ERRATA #1 – MAY 7, 2020

Freeway Segment Density Pie Charts

Figure 7-6: 2025 AM Freeway Segment Densities for I-495 Southbound GP Lanes

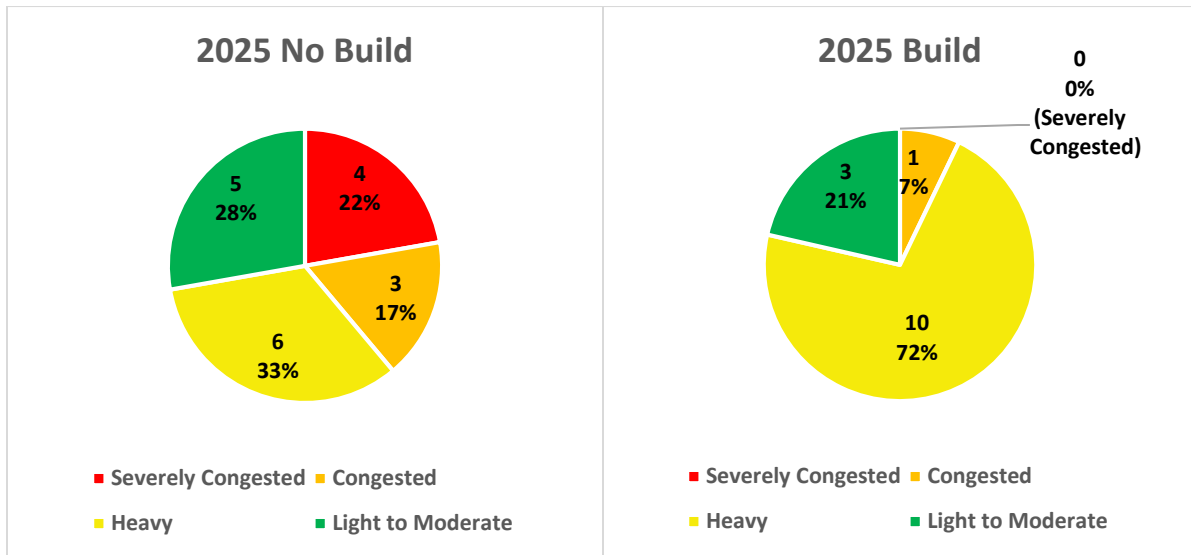
Several freeway density pie charts incorrectly included some ramp movements within the tabulation of congested or severely congested freeway mainline segments. The following figures have been updated to correctly show congestion on the I-495 mainline lanes:
